2016-036

Subject: Project No. 704 – BWRVIP Response to BWRVIP-234 Draft Safety Evaluation

DRAFT SAFETY EVALUATION OF THE BWRVIP-234 REPORT

BWRVIP Comment Summary Table

Figure A1. Plot of predicted lower-bound J @ 2.5 mm (BWRVIP-100 and NRC staff proposed) vs. neutron fluence. Arrow reflects shift of BWRVIP-100 curve to the left, represents assumed contribution to lower-bound J @ 2.5 mm due to IE.

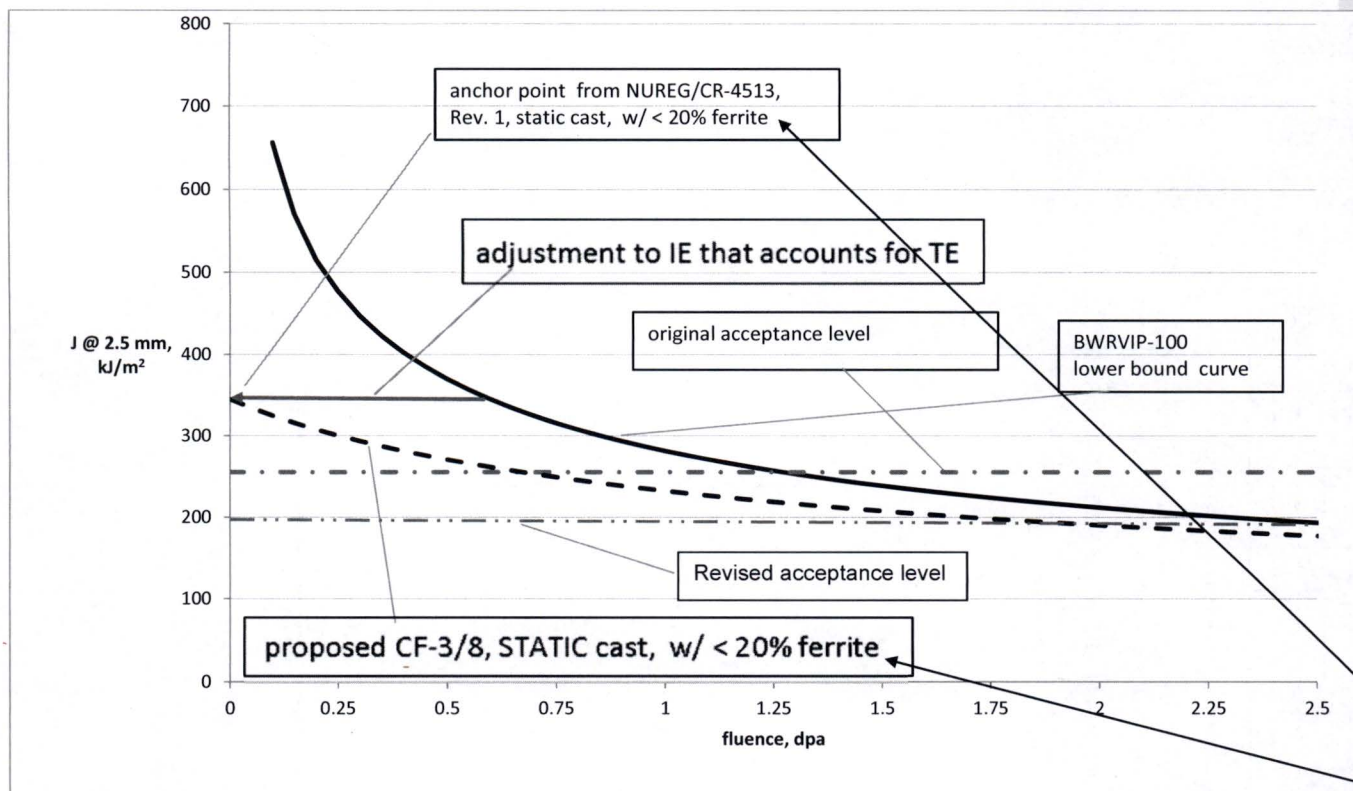
Commented [C-WC5]: The "< 20 % ferrite" values in Figure A1 need to be changed to "≤ 20% ferrite" to be consistent with Table A1.

5	Second page of Appendix A, Figure A1	Accuracy	The "< 20 % ferrite" values in Figure A1 need to be changed to "≤ 20% ferrite" to be consistent with Table A1.	
6	Headers throughout	Clarification	As the SE does not contain any EPRI proprietary information, "Proprietary Information" can be removed from the headers.
